**REQUEST FOR INFORMATION      DATE: June 27, 2016      NO.: RFI-185**

Project Name: 15051-Webster University Interdisciplinary Science Building      Project No.: 15051

Subject: Concrete Wall Dimensions

A0101.EB

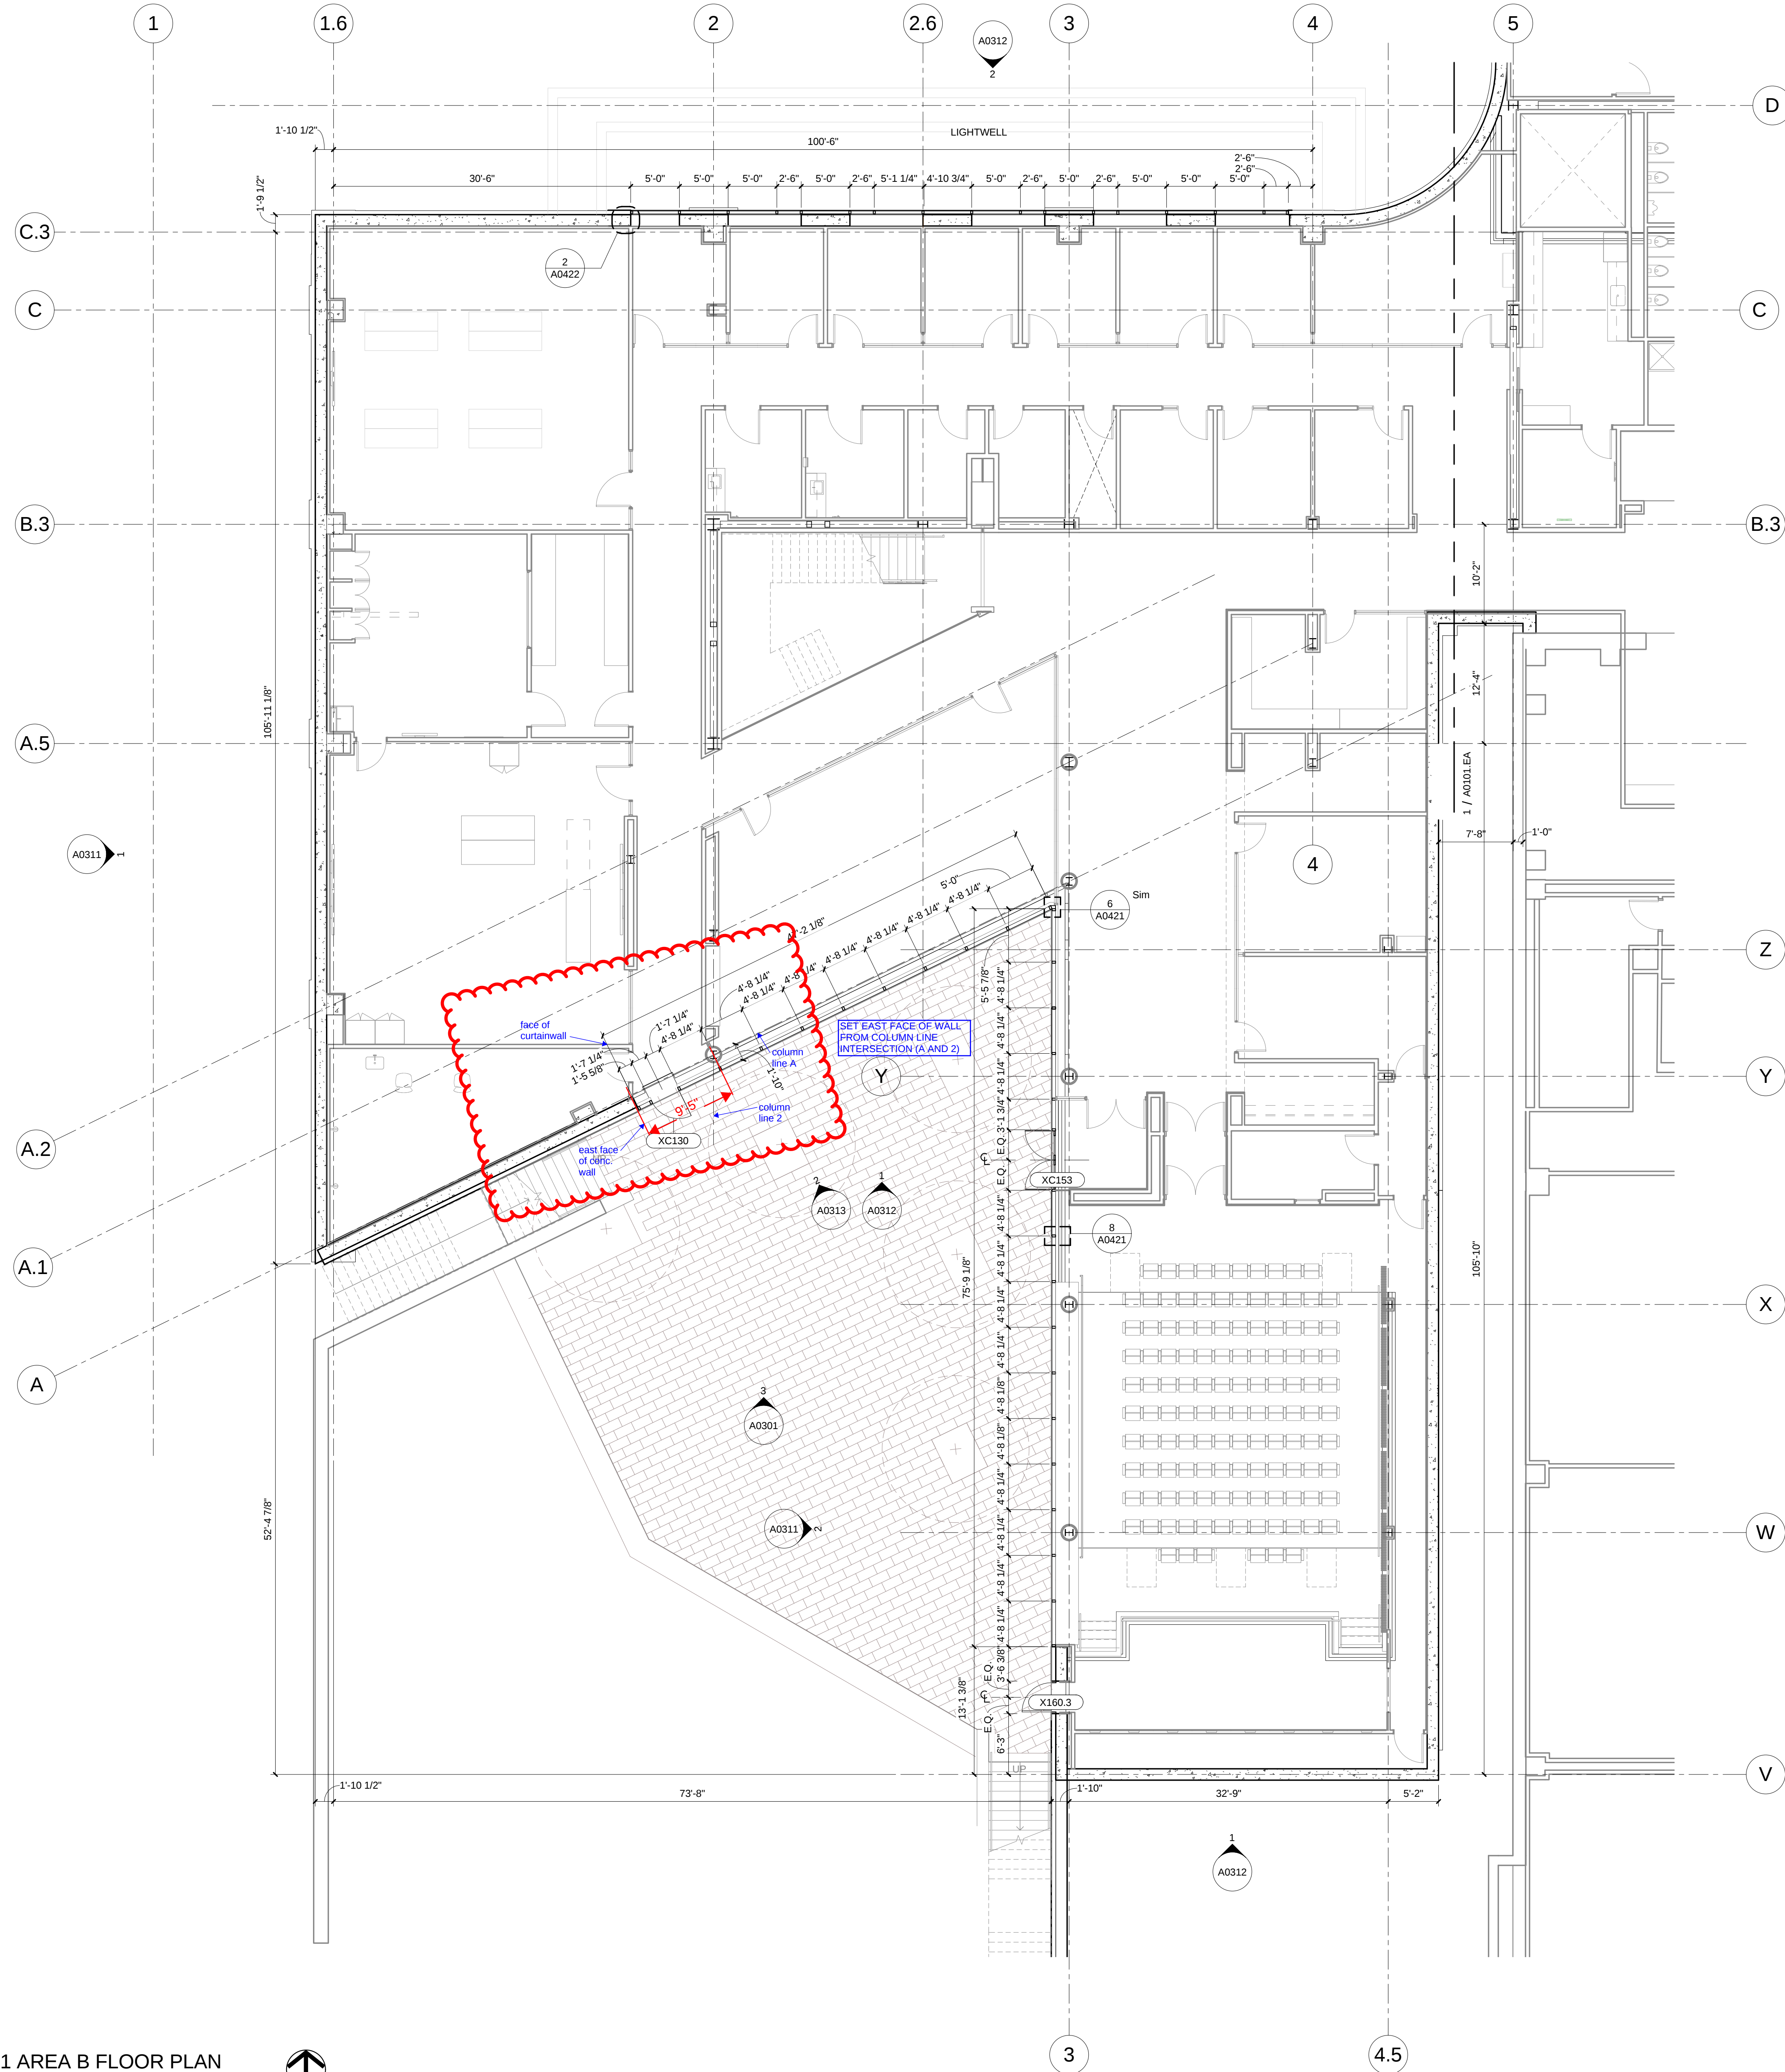
We cannot find a hard dimension for the level 1 concrete wall along A line from 1.6 line to 1.9 line. We were able to pull 36' 9 5/16" from the southwest corner of the wall to the end at 1.9 line. Please confirm dimension.

SEE ATTACHED: SET EAST END OF WALL FROM INTERSECTION OF COLUMN LINE 2 AND COLUMN LINE A. (THE DIMENSION INDICATED SHOULD BE CLOSE.)

NOTE: TOP OF WALL BETWEEN 1.8 & 1.9 IS NOTCHED FOR W16 CONN TO PILASTER - SEE CONCRETE REINF SHOP SUBMITTAL RETURNS AND ADD #1-11
